## ASSESSMENT REPORT

### MIRANDA DENTAL HOSPITAL MP 11\_0009 (MOD 3)

Figure 6- Northern elevation (Proposed MOD 3)

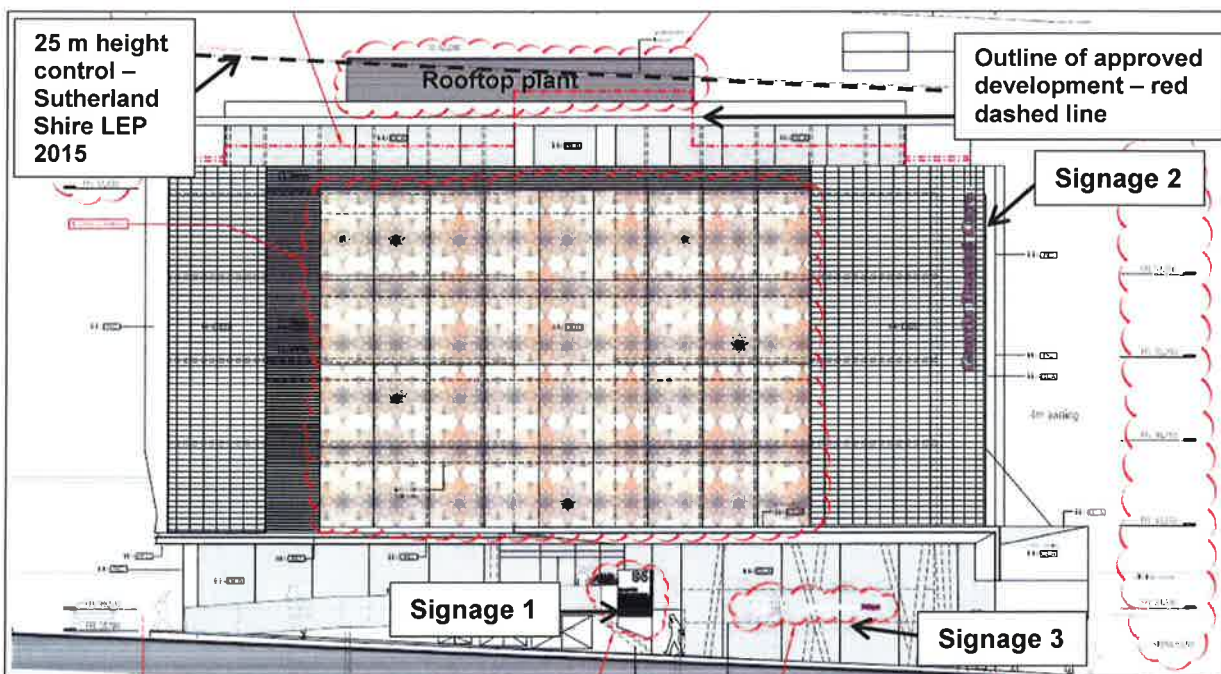
Council also provided comments regarding the lack of justification for increasing the building height above the 25 metre height limit and sought clarification regarding aspects of the hydraulic analysis in the Proponent's flood assessment report.

The proposed changes would result in the development slightly exceeding the 25 m height control under *Sutherland Shire Local Environmental Plan 2015* (LEP 2015) by a maximum of 470 mm at the north-western corner of the plant room (refer to **Figure 6**). Council raised concern about the increase in building height above the 25 m height control under LEP 2015.

The Proponent's RtS provides justification for the proposed increase in building height, stating that only the rooftop plant room louvre screening exceeds the 25m height limit, the objectives of the building height standard are still met, the scale of the building is consistent with the character of the street and the minimal increase will not have any amenity impacts.

- the encroachment above the 25 m height control is minor and relates to the proposed plant room which is set back from the edge of the building and appropriately screened to ensure it would not form a dominant visual element of the building (refer to **Figure 8**);
- the scale of the proposal is compatible with the adjacent Westfield Shopping Centre which has a height control of 30 m; and
- the additional building height would not result in any unreasonable overshadowing, view loss or privacy impacts on the surrounding commercial properties and the public domain.

**Figure 10- Proposed access arrangements**

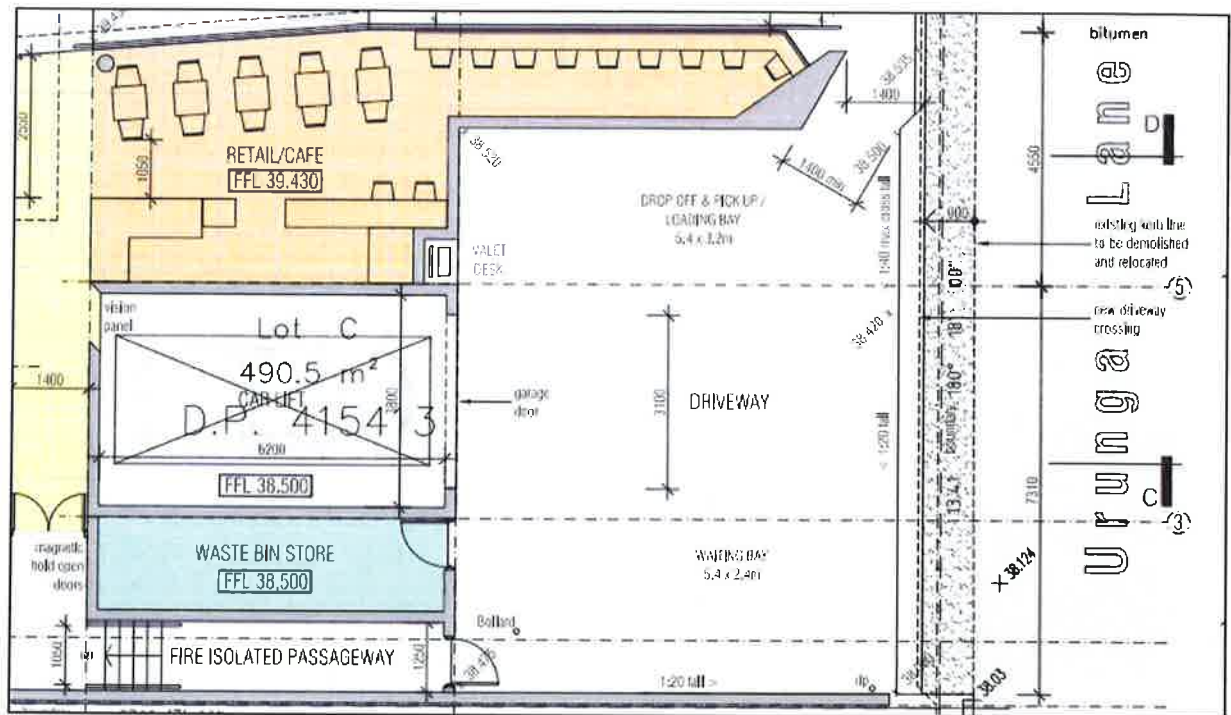
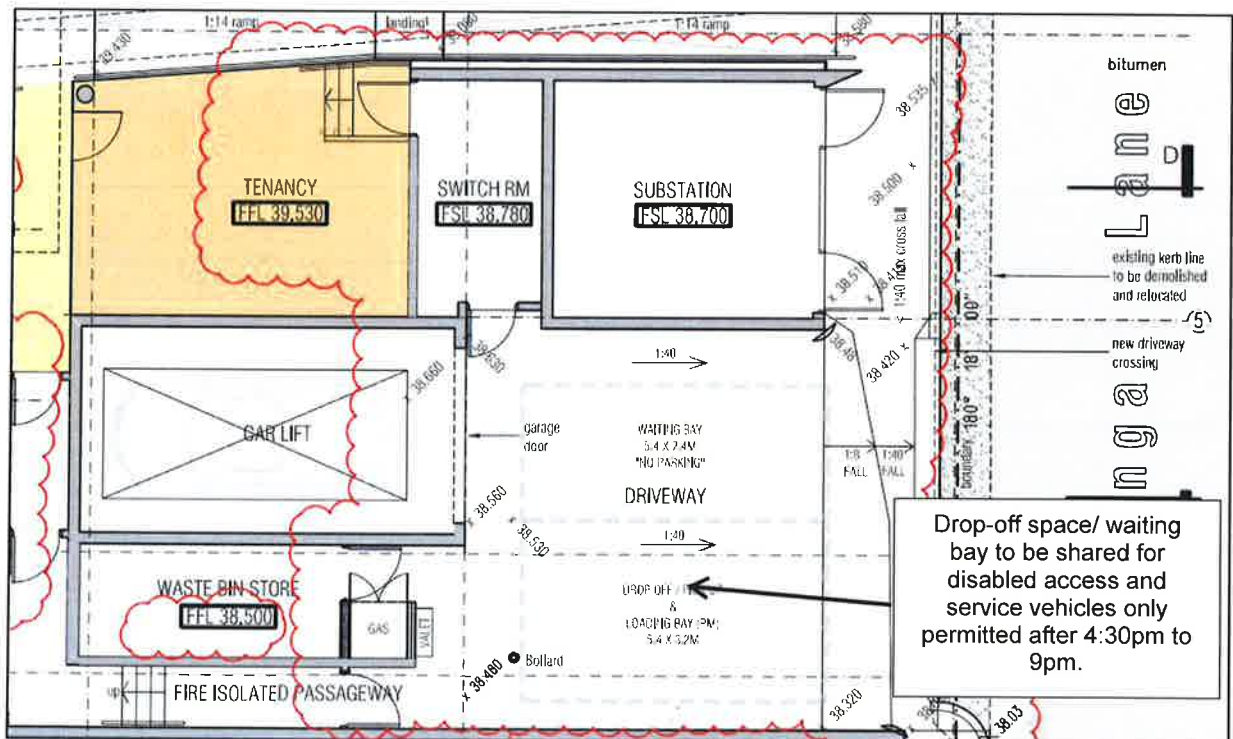
The proposed modification seeks to reconfigure the access arrangements to accommodate a substation required to service the development. This has reduced the space available for vehicular access. A combined drop-off/ pick-up/loading bay and a waiting bay located within the driveway is now proposed (see **Figure 10**).

Council has raised concerns with the plans showing the disabled car space being shared with a loading bay and considers the disabled car space should remain free and accessible at all times.

In response, the Proponent has confirmed the space would be used as a drop-off/ waiting bay only and not a disabled parking space, but it would allow for people with a disability to be dropped off. The space would also be used as a loading bay for service vehicles after patient visitor hours, between 4:30 pm - 9:00 pm.

The Department considers the proposal would provide appropriate access for persons with a disability in accordance with relevant requirements, noting a valet would be on site to assist patients and to manage other vehicle movements. However, the Department does not support restricting the hours where patients with a disability can make appointments and considers such a restriction to be unreasonable. A condition is therefore recommended requiring the OTMP to be updated to remove this restriction, so that persons with a disability can access the facility at any time during normal patient hours. A condition is also recommended requiring an update of the OTMP to include management protocols to enable staff members with a disability to work at the site and access the carpark. In addition, a condition requiring signage within for drivers entering the site, outlining the waiting arrangements is recommended.

The Department has also considered the potential traffic impacts associated with the modified access arrangements, particularly as a result of the reduced space available for access and the combined use of the driveway for a waiting space. This has the potential to cause conflicts with vehicles entering and exiting the stacker, particularly for visitors and patients who are not familiar with the waiting and entry arrangements. However, the Department notes the access arrangements would be carefully managed in accordance with the OTMP. Further, existing condition G10 requires the provision of a full time valet (during patient hours) who would be responsible for the management of vehicle movements within the waiting / driveway area. The Department considers the provision of a valet during patient hours, in conjunction with appropriate training for staff and instructional signage would ensure access by staff and visitors can be adequately managed to appropriately minimise potential traffic queuing and congestion.
